V2500-A5/D5 SERIES PROPULSION SYSTEMS SERVICE BULLETIN

This document transmits Revision 1 to Service Bulletin EV2500-72-0242 and the Initial Issue of the Supplement

V2500-ENG-72-0242

ENGINE – HP TURBINE ROTOR AND STATOR ASSEMBLY – PROVIDE NEW STAGE 1 HPT BLADES

LOCATION OF THE STAGE 1 HPT BLADE
Fig.1

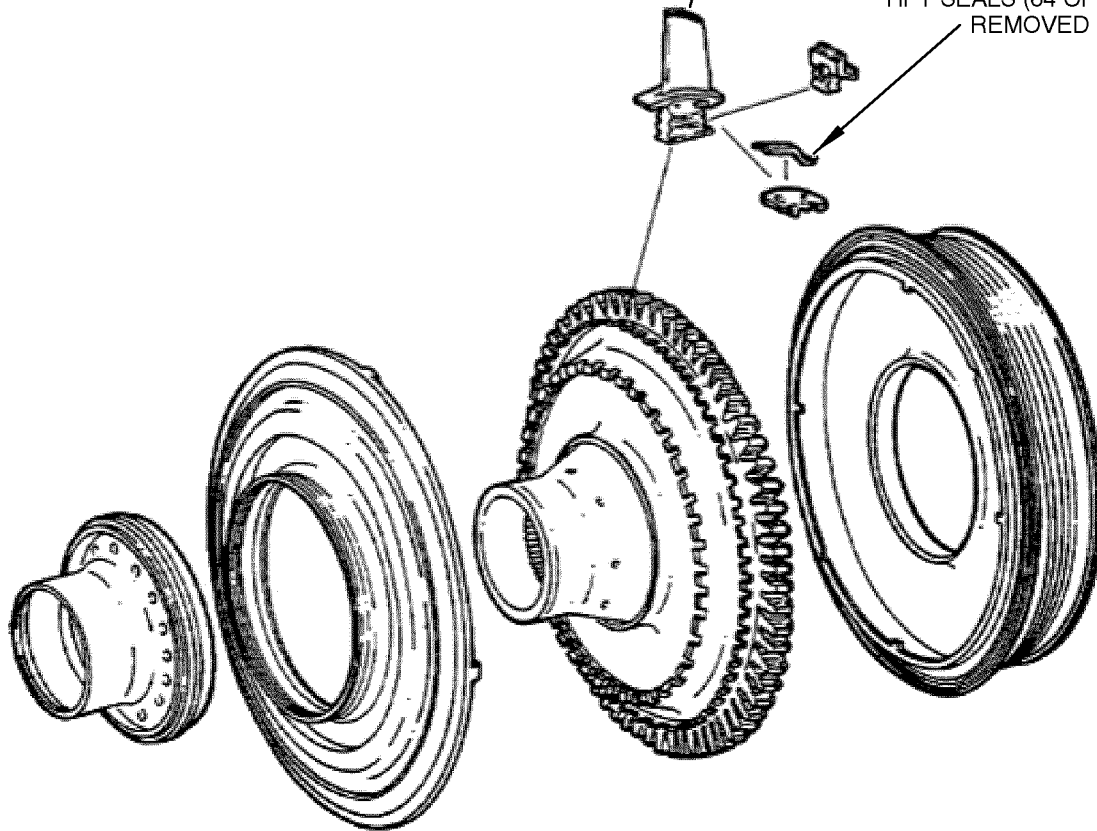
INSTALL THE 2A8801 STAGE 1 HPT
BLADE (64 OFF)

THE 2A0530 STAGE 1
HPT SEALS (64 OFF) ARE
REMOVED
